29 August 2019

BUILDING CODE OF AUSTRALIA CAPABILITY STATEMENT - Rev B
Property/Project: Sydney Opera House – White Box (TIDE) – Bennelong Point, Sydney

Table 1 – Documentation Assessed

Figure 1 – Part Existing Fire Rating Plan – White Box area illustrated in green

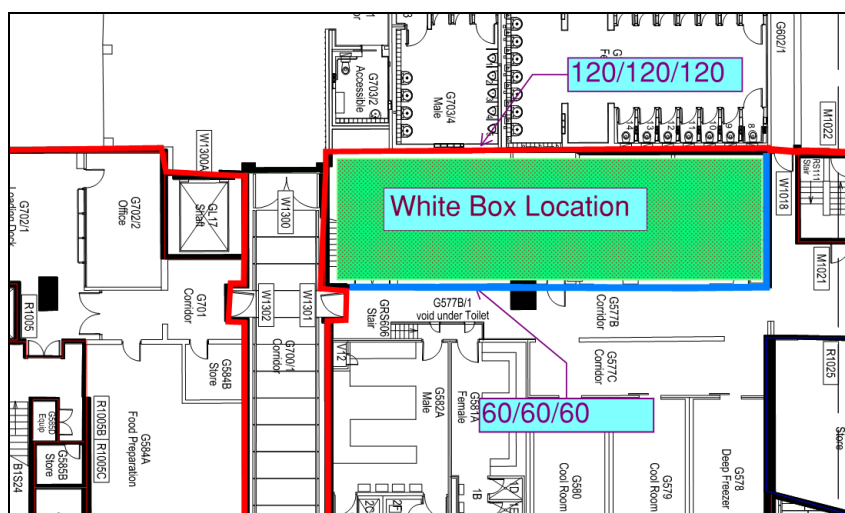
The relevant existing Arup Fire Compartmentation plan (Fire Compartments and Fire Door – Level GR South West 2018 Audit dated 12-11-2018, see Figure 1 below) illustrates a fire compartmentation line/wall to the east perimeter of the White Box. The proposed changes to this wall (provision of a new opening to house a sliding door exit) will not see a decrease in the required fire rating of 120/120/120. The southern and eastern lines/walls are noted in the existing fire compartmentation plans as containing an FRL of 60/60/60. This 60 minute fire rating is not required to be maintained as the proposed White Box is neither a storage room, stage, back stage area or an auditorium. The Fire Compartmentation plans can be updated following issuance of the Crown Completion Certificate for this project.

Figure 2 – Travel Distance Assessment

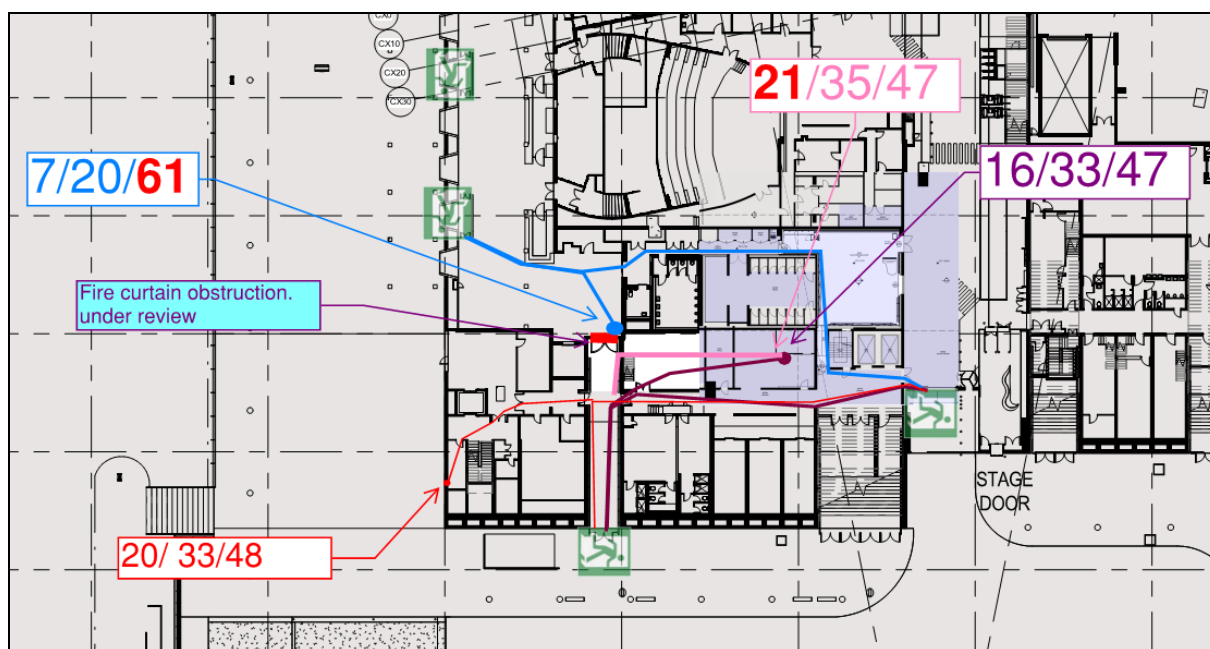
Whilst travels distances are altered slightly, the proposal has low impact on the current egress situation. Diagram 1 below illustrates excessive travel distances in the following areas as illustrated in Table 3 below, worst case scenarios illustrated only:

Location	DTS Travel Distance Requirement	Actual	Design Team Nominated Resolution
Western Foyer (as illustrated in blue in Figure 2.)	20/40/60	7/20/61	Under review. Option to delete the fire curtain currently being explored, which will solve this issue.
Oculus - Eastern most point (as illustrated in red in Figure 2.)	20/40/60	21/35/47	The Fire Safety Engineer has confirmed the feasibility of a Performance Solution which will be justified within the pending FER However, this scenario is only applicable if the southern staff access swing door is deleted. Currently under

Location	DTS Travel Distance Requirement	Actual	Design Team Nominated Resolution
			review.
